The above schematics from the DUET documentation show the drive circuit and the ribbon cable output J2. There are tracked but unpopulated positions for the connectors J5 and J4 which offer a non-ribbon cable alternative. However J14 the “EXT FET” 2 pin header is provided next to the ribbon cable connector J2.

The proposal below is to remove the high currents for the heater bed off of the DUET board.

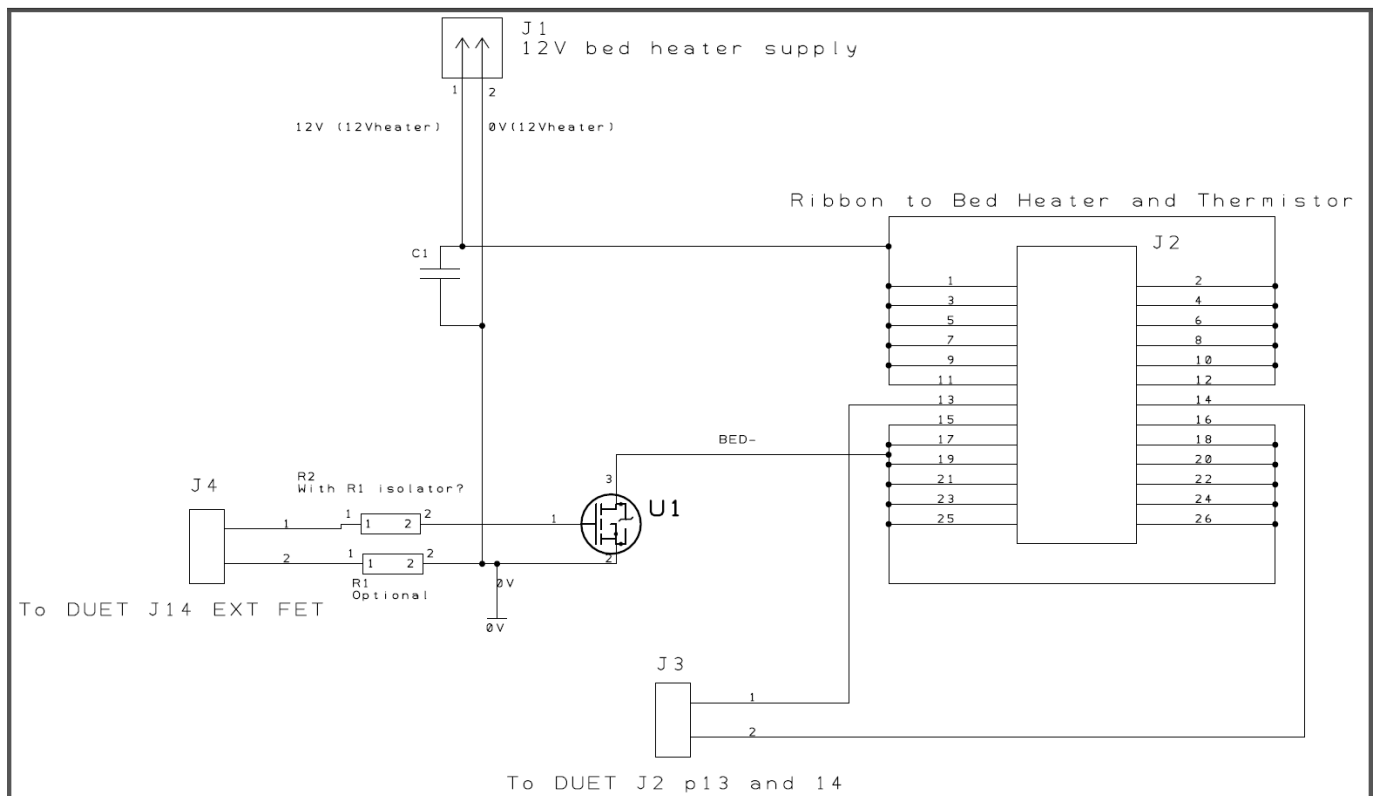
J4 above connects to J14 on the DUET board and provides the FET drive signal.

J3 above connects to pins 13 and 14 of the DUET ribbon header J2. Note that the DUET pins could now go direct to the thermistor via a different physical route to provide better isolation from the heater switching noise.

J2 is the new connection for the ribbon cable to the bed heater. This could be physically re-routed to the opposite end of the Ormerod platform and if the new PCB above is located at that end (power PCB end) this will keep the power to the Ormerod at one end.

R2 is suggested as a low wattage resistor say 10R (possibly with a ferrite bead) to provide a degree of ground isolation but more importantly protect the wiring and DUET tracks by fusing should the 12V heater supply ground become disconnected and the bed heater current try to return to the PSU via this signal route.

The combination of R2 and R1 shows the location only, i.e. not suggested components, to place an isolator for improved ground noise isolation to the DUET.

C1 is suggested for power supply hold up and may be in parallel with other capacitors for better noise suppression.

Not shown, but the board should also have spike suppression as a diode or diode R+C circuit across the heater.

J1 provides the 12V bed heater current, which could be a separate supply, but I believe could be taken from the existing PSU via the alternative free plugs. Two cables need to go back to the DUET for the FET drive signal and the bed thermistor. Additional options for isolation and noise suppression can be added as required.
